RE: Amerada Hess Corp- Former Port Reading Refinery
EPA ID No. NJD045445483
750 Cliff Road
Woodbridge Township, Middlesex County
PI#: 006148

**Comment Letter: Pre & Post Closure Groundwater Sampling Plan for AOC 3: No. 1
Landfarm Response to Comments**

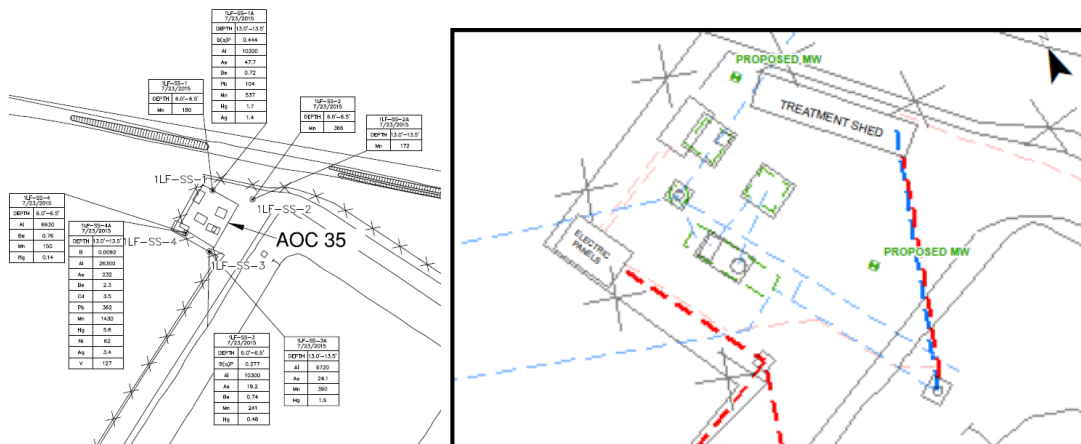
Proposed Wells: Two additional wells are described and shown on Figure 1 (attached). One well appears to be downgradient of former leachate/storm water piping, oil/water separator and oil sump. A second well is closer to the No. 1 Landfarm limits along downgradient flow paths from a large portion of the land treatment area and between L1-2 and L1-3. The Department concurs with the proposed well locations.

2015 SIR Figure 28 AOC 35:

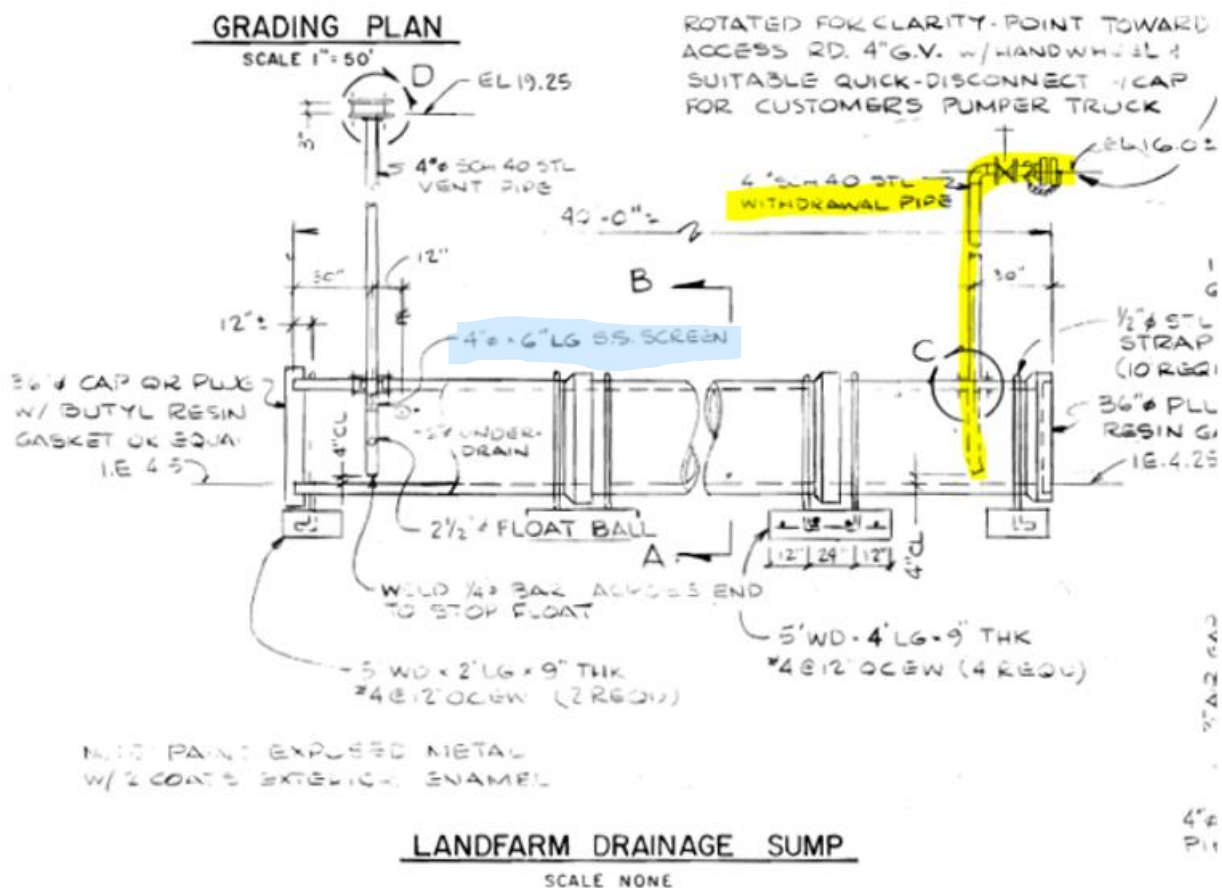
9. In the figure above, identify storm water treatment/management/discharge changes since cessation of discharge to the AWWT Plant and information that leachate is directed to the treatment plant without mixing with storm water. The April 27, 2022 site visit identified storm water storage in frac tanks.
10. Based on the figure above, clarify and list the structures that were associated with No. 1 Landfarm operations. This would appear to include the 40-foot leachate sump and manhole; AOC 35 units (e.g., piping outside of the landfarm, oil sump, oil/water separator, etc.); and the current treatment works (piping/building).
11. All units associated with the RCRA land disposal unit need to be included in the RCRA closure process. Investigation and closure plans will be needed for these structures. A schedule is requested.
